MEETING OF THE HISTORIC DISTRICT COMMISSION

6:30 p.m. June 05, 2024

AGENDA (revised on May 31, 2024)

BRICK & SILL SUBSTITUTIONS

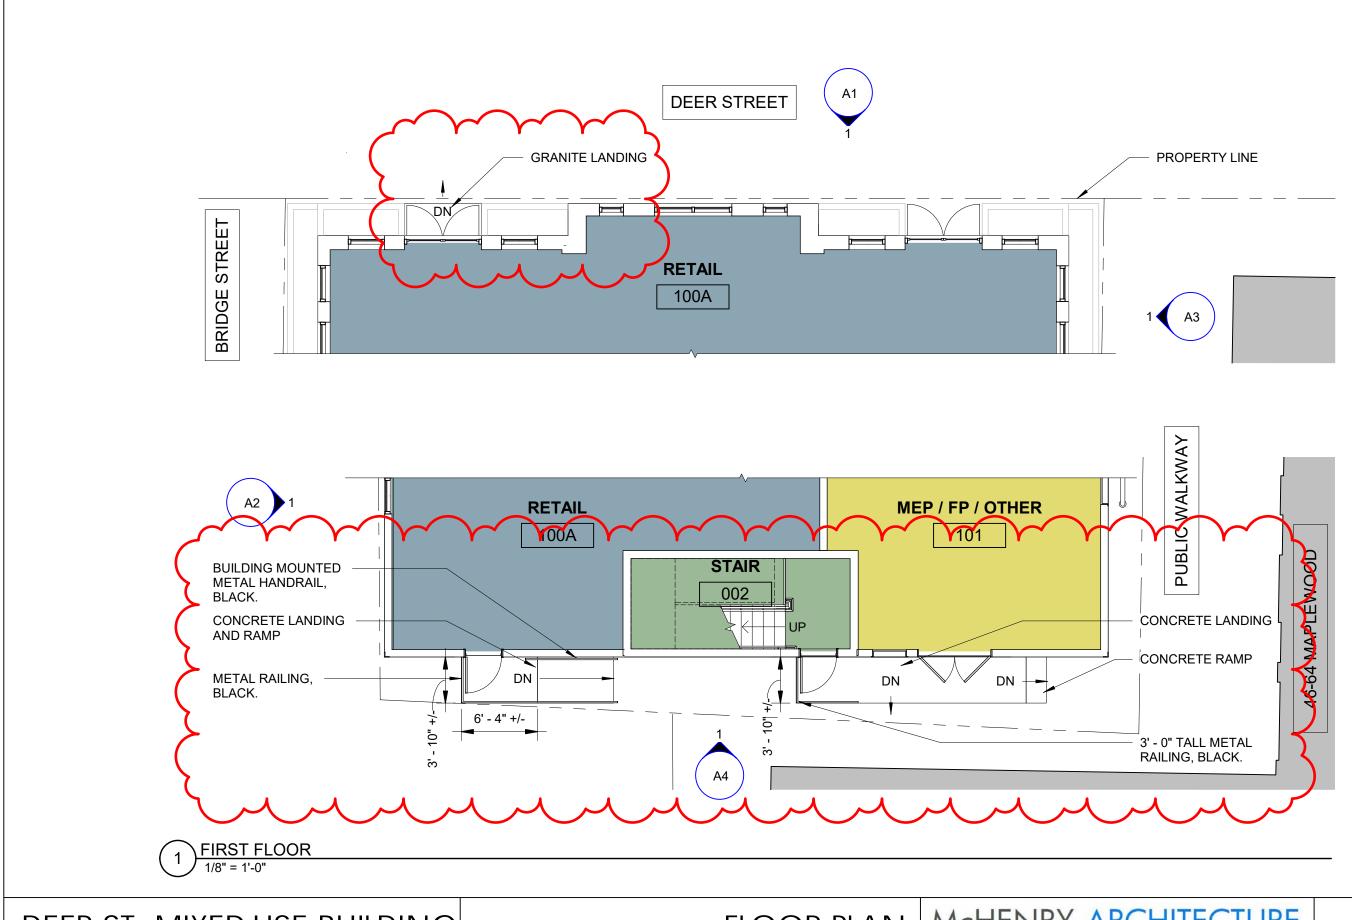
- PROPOSED ALTERATIONS AND ADDITIONS FROM PREVIOUSLY APPROVED APPLICATION ON 11/10/2021 AND ADMINISTRATIVE APPROVAL ON 07/06/2022 AND 02/13/2024:
 - CHANGE IN BRICK SELECTION, PREVIOUSLY APPROVED BRICK IS NO LONGER AVAILABLE. PROPOSED BRICK IS SIMILAR IN COLOR AND TEXTURE, RECOMMENDED BY MASON.

- ADDITION OF GRANITE LANDING AT RIGHT SIDE OF THE DEER STREET **ELEVATION ENTRY DOOR.**
 - BRICK WINDOW SILLS TO BECOME BLUESTONE SILLS, BRICK SELECTION DOES NOT PROVIDE SOLID BRICKS TO BE USED FOR SILLS.

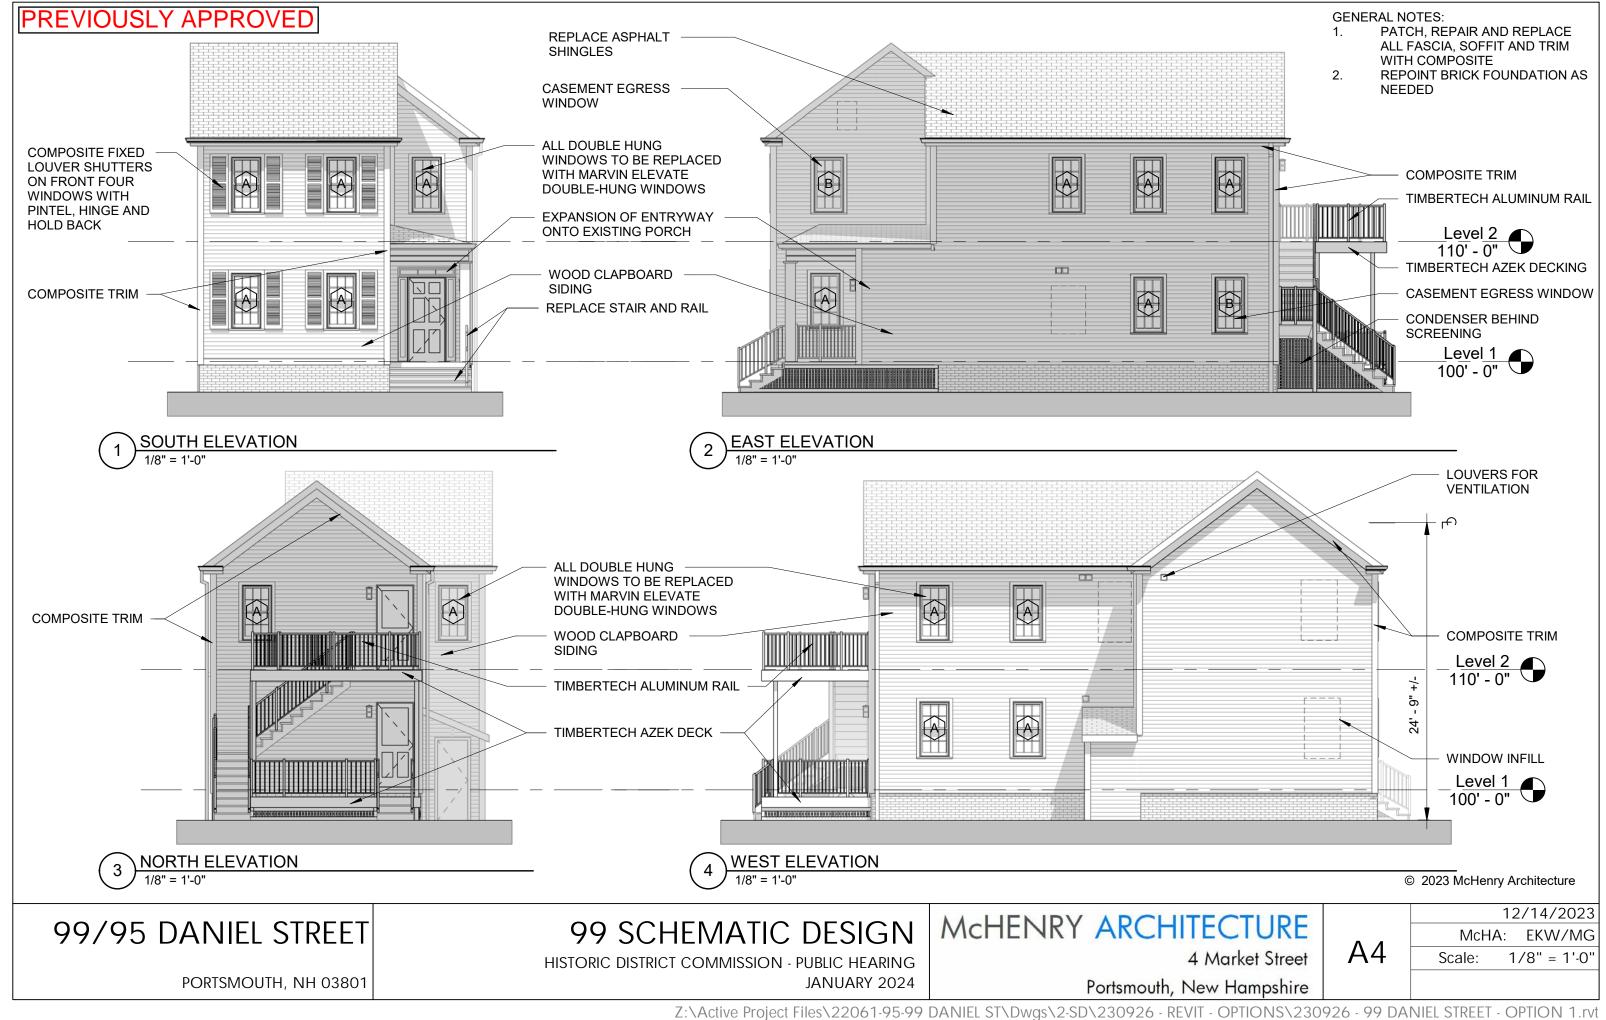
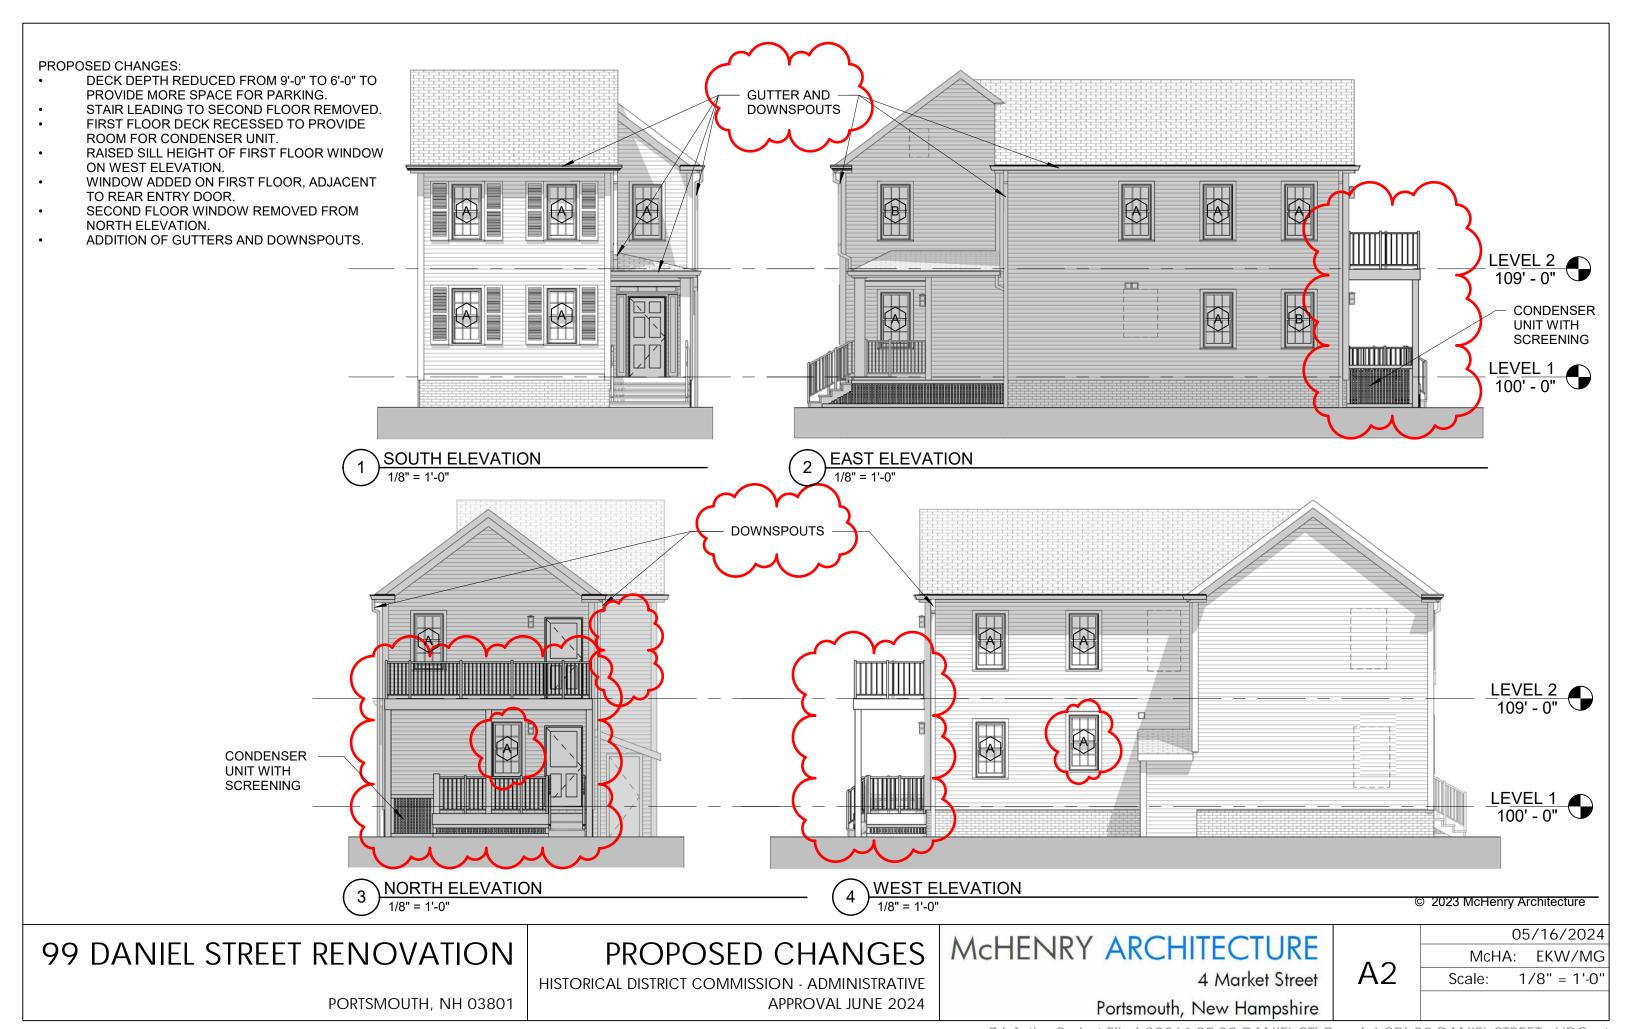
DECK DEPTH REDUCED FROM 9'-0" TO 6'-0" TO PROVIDE MORE SPACE FOR PARKING.

- STAIR LEADING TO SECOND FLOOR REMOVED.
- FIRST FLOOR DECK RECESSED TO PROVIDE ROOM FOR CONDENSER UNIT.
- RAISED SILL HEIGHT OF FIRST FLOOR WINDOW ON WEST ELEVATION.
- WINDOW ADDED ON FIRST FLOOR, ADJACENT TO REAR ENTRY DOOR.
- SECOND FLOOR WINDOW REMOVED FROM NORTH ELEVATION.
- ADDITION OF GUTTERS AND DOWNSPOUTS.

70 MAPLEWOOD (LOT 5)

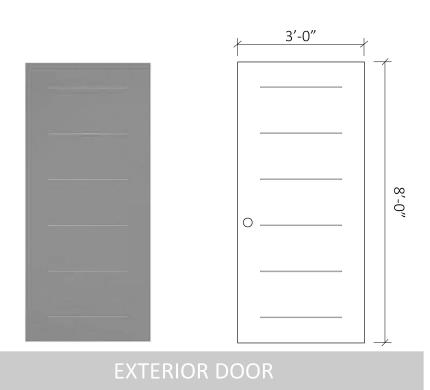
OPENINGS ON THIS CORNER ELEVATION NEED TO BE REVISED
TO ACCOMMODATE THE BUILDING POWER ENTRANCE ON THE
CORNER OF THE SITE, AND LINES RUNNING INTERNALLY.
SEE RENDERING ON SHEET 3.0.

5) EXTERIOR BRACKET SPACING: THE BRACKETS HAVE BEEN DOUBLED AND POSITIONED ON THE BRICK PIERS AND NOT WITHIN THE BRICK RECESSED AREAS.

2) ELECTRICAL ROOM WINDOWS AND DOOR:
OPENINGS IN THE WALL WILL NEED TO BE REVISED
TO ACCOMMODATE THE BUILDING POWER
ENTRANCE ON THE CORNER OF THE SITE, AND LINES.
RUNNING INTERNALLY.
EXTERIOR DOOR: SEE SHEET 2.2.
SEE RENDERING ON SHEET 3.0

RAIL CORRIDOR ELEVATION - PROPOSED

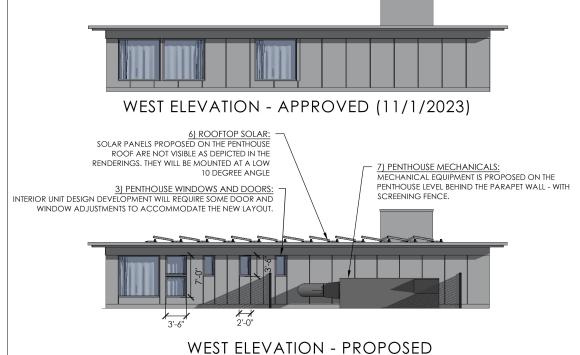
8) GARAGE LOUVERS: GARAGE LOUVERS: ARE EXEMPT AS THEY ARE PAINTED TO MATCH THE BRICK AND DO NOT EXTEND MORE THAN SIX INCHES. 10.633.20 EXEMPTIONS FROM CERTIFICATE OF APPROVAL: (8): PLACEMENT OR REPLACEMENT OF WALL-MOUNTED
MECHANICAL OR ELECTRICAL EQUIPMENT AND VENTILATION
TERMINATORS WHERE THE EQUIPMENT (1) IS PAINTED A SIMILAR COLOR TO MATCH OR BLEND WITH THE WALL COLOR, (2) DOES NOT EXTEND MORE THAN SIX INCHES OUT FROM THE WALL PLANE, AND (3) DOES NOT VENT DIRECTLY INTO A PUBLIC WAY: AND WHERE (4) ALL DUCT WORK OR EQUIPMENT FEEDS ENTER THE BUILDING'S INTERIOR AT GROUND LEVEL SO AS NOT TO BE VISIBLE.

H1.3 ROOF PLAN

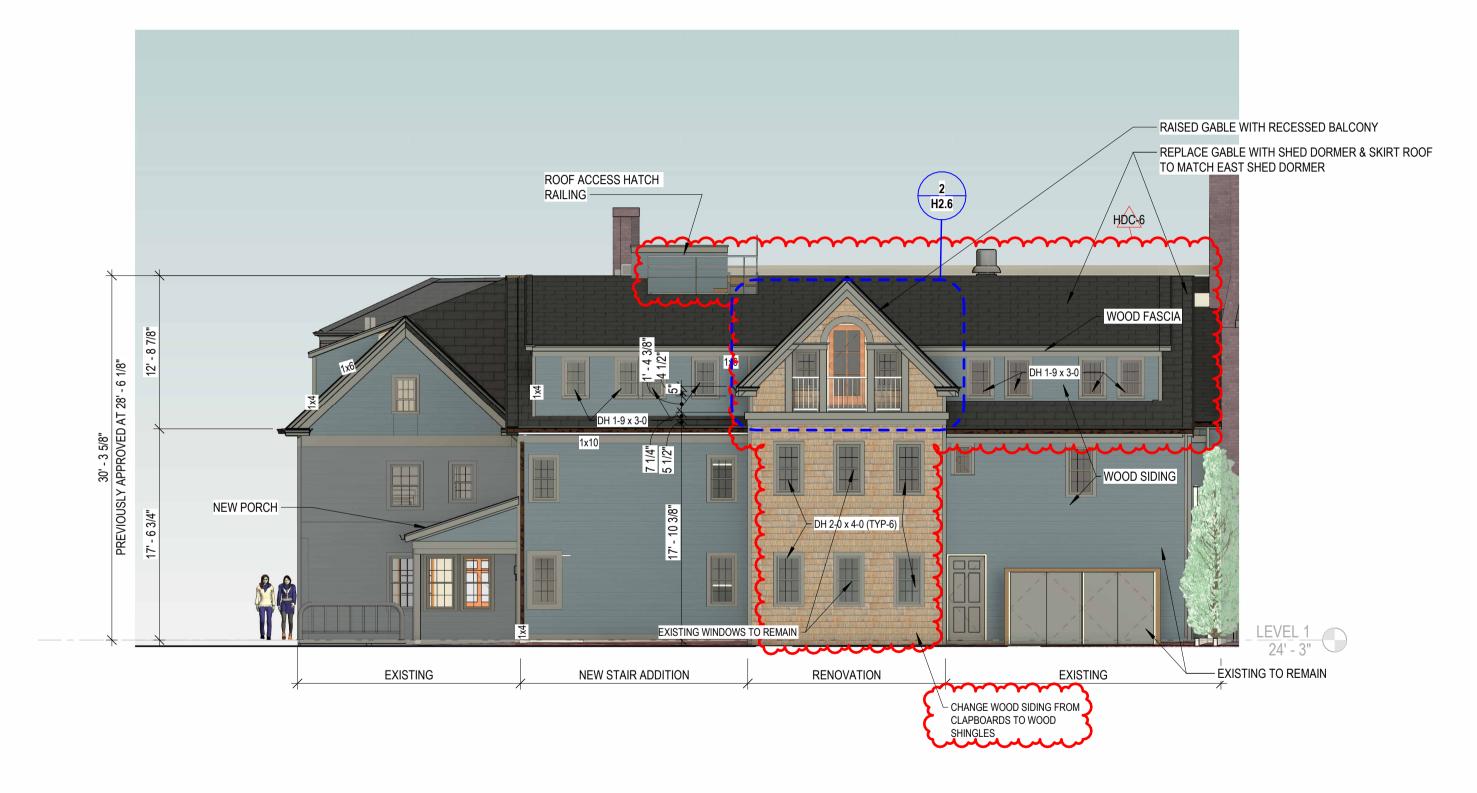
- 1. RAISE CENTER REAR GABLE, ADD RECESSED PORCH
- 2. CHANGE REAR WEST GABLE TO SHED DORMER.
- 3. EXTEND FLAT ROOF BEHIND GABLES
- 4. ADD FOUR WINDOWS TO EXISTING REAR CENTER GABLE
- 5. CHANGE WOOD SIDING ON EXISTING CENTER REAR GABLE FROM
- CLAPBOARDS TO SHINGLES
- 6. ADD ROOF HATCH AND GUARDRAIL TO SHEAFE ST ROOF
- 7.FRONT ENTRY DOOR CHANGED FROM DOUBLE TO SINGLE WITH SIDELITES
 8. CHANGE STOREFRONTS FROM 'NANA' FOLDING WINDOWS TO 'KOLBE'
- SLIDING WINDOWS
